For Immediate Release: Sept. 28, 2020

NEW!  **RC8B3 FT 4-shoe Steel Flywheel**

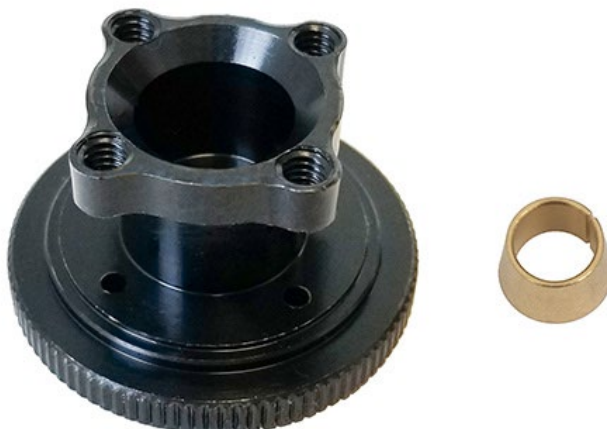
The new optional #81463 RC8B3 FT 4-shoe steel flywheel is a direct replacement for the standard #81370 RC8B3 aluminum 4-shoe flywheel. The steel flywheel is heavier than the aluminum flywheel and increases the overall rotating mass of the clutch assembly. This offers a more stable engine idle and a smoother bottom end throttle feel.

New: #81463 RC8B3 FT 4-shoe Steel Flywheel = ~36 grams

Standard: #81370 RC8B3.1 4-shoe Aluminum flywheel = ~12 grams

Fits all RC8B3 and RC8T3 series vehicles and .21 off-road nitro engines.
